**RESOLUTION NO. 2019 - 08  
LOWER PROVIDENCE TOWNSHIP**

**A RESOLUTION OF THE LOWER PROVIDENCE TOWNSHIP  
BOARD OF SUPERVISORS, MONTGOMERY COUNTY,  
PENNSYLVANIA, APPROVING THE PRELIMINARY/FINAL LAND  
DEVELOPMENT PLAN FOR HTC ASSOCIATES, LLC FOR THE  
PROPERTY LOCATED AT 28 EAGLEVILLE ROAD**

Reference: 28 Eagleville Road  
Land Development Application

SUBJECT: **REVIEW COMMENTS – 28 EAGLEVILLE ROAD**  
**LAND DEVELOPMENT PLAN DATED NOVEMBER 1, 2018**

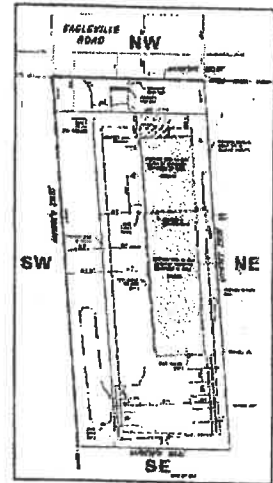
These comments use the directional references for the property boundaries that are indicated to the right.
